CONSULTEE RESPONSE (Council's arboriculturist)

Reference: M/16/22/PL

Proposal: Laying out of an 18 hole 72 par golf course, a 9 hole golf course, practice greens and a driving range including a buggy compound; the formation of a new access onto the A259; construction of a club house with associated golf club facilities; the construction of a maintenance building and external area of hardstanding; the laying of parking, new roads and paths; new landscape planting; surface water drainage basins and water storage reservoirs; and other earth works and infrastructure. This application also lies within the parishes of Climping and Yapton, is a Departure from the Development Plan and affects a Public Right of Way. This application is subject to an Environmental Statement.

Location: Land South of Grevatts Lane/A259, Climping

Figure 1. Map showing position of T4 oak & T5 maple proposed for TPO.

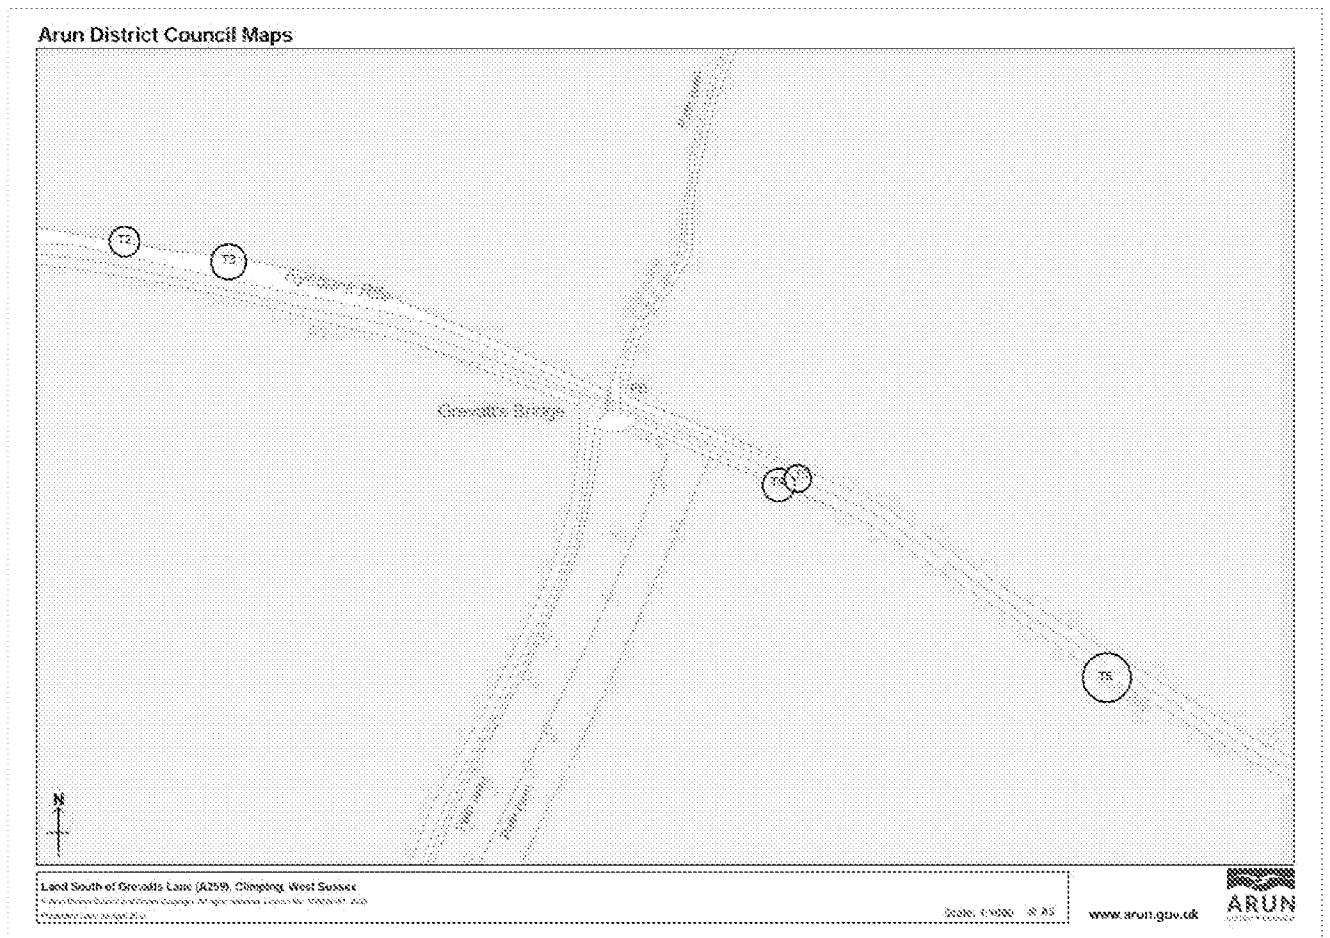
There is a potential area of conflict which I feel needs to be resolved around the terminus of hole 18; a substantial section (capturing part of tree groups G3 and G4) is to be removed. Within that section I suspect are two higher quality trees (retention category A/B) that I have identified for TPO (fig.1).

The general 'principle of development' as described is achievable without undue detriment to higher value trees, but it requires a more sympathetic approach to the tree line east of Grevatt's Bridge. I suggest the applicant be encouraged to revisit this area of the layout.

I recommend the making of a Tree Preservation Order in respect of **three oak and three maple** to preserve their place in the landscape and inform a revised layout. TEMPO forms and GIS plan for this purpose can be found here: [REDACTED]
